Report No.: 50-261/95-13

Facility Name: H. B. Robinson Plant Unit 2

Inspection Conducted: April 17-21 and May 15-19, 1995

Figure 1 Stud No 2

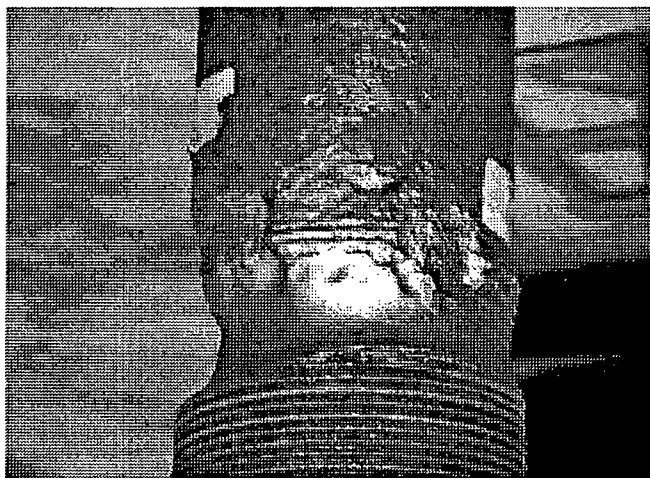
The LSSMU requested that stud No. 2, the most severely degraded stud, be sent to the HE&EC for metallurgical evaluation. Upon his arrival at the site, the inspector was informed that the studs removed from the C RCP were in the Hot Machine Shop (HMS). The licensee indicated that stud No. 2 had been marked "save" per the system engineer, pending its shipment to HE&EC. When the inspector accompanied by the licensee went to the HMS to examine the studs, only one stud, of the eight removed, could be found. Stud No. 2 was subsequently found, decontaminated by sand blasting, in a trailer destined for burial at the low level

radioactive waste disposal facility at Barnwell SC. The sand blasting had removed the corrosion product/base material interface, thereby rendering the stud of little value for metallurgical evaluation. Eventually a total of four studs were located. The licensee was able to identify stud No. 2 because of the degree of wastage exhibited. The remaining three could not be correlated with respect to their removal location, with any degree of certainty, because they were not marked after pressure washing and before removal from the pump. The above demonstrates a weakness in the control of metallurgical failure analysis specimens.

Figure 1 above shows the wastage on stud No 2 after sand blasting. The wastage is located on the stud at the stud lower thread/pump body interface.

The inspector conducted a walkdown inspection of C RCP. Examination of stud Nos. 22 and 7 (the studs immediately adjacent to the replaced studs), revealed a significant amount of wastage. It should be noted that the wastage was not visible without the aid of a mirror or other indirect viewing device.

After some investigation, it appears that the licensee accepted at face value, that the eight degraded studs required replacement and the remainder of the studs were acceptable ("OK") based on the tactile examination conducted by the LSSMU prior to pressure washing. The licensee subsequently pressure washed the area to remove the potential threat of renewed boric acid wastage. This washing removed additional boric acid and corrosion products, from the studs, revealing additional wastage, on the studs adjacent to the studs previously identified as degraded. This degradation was in areas not accessible to direct view. The eight previously identified degraded studs were replaced. No further visual examination, of a type that would have detected the degradation on stud Nos 22 and 7, was attempted or planned for the remaining studs. Absent the NRC intervention, the plant would have returned to operation at the close of the outage with at least two degraded studs in place in C RCP without an evaluation of operability.

TS 6.5.1.1, Procedures, Tests, and Experiments, requires in part that written procedures be established, implemented, and maintained covering activities recommended in appendix A of Regulatory Guide 1.33, Rev. 2, 1978 including procedures for inspections. The licensee failed to establish adequate work instructions (procedures) requiring direct or indirect visual inspection of the C RCP studs after the removal of the boric acid residue and corrosion products. This failure permitted degraded studs to remain in the RCP without an evaluation of operability. This failure to provide adequate procedures will be identified as: **Violation 50-261/95-13-01: "Failure to Provide Adequate Work Instruction for Degraded Stud Inspection."**
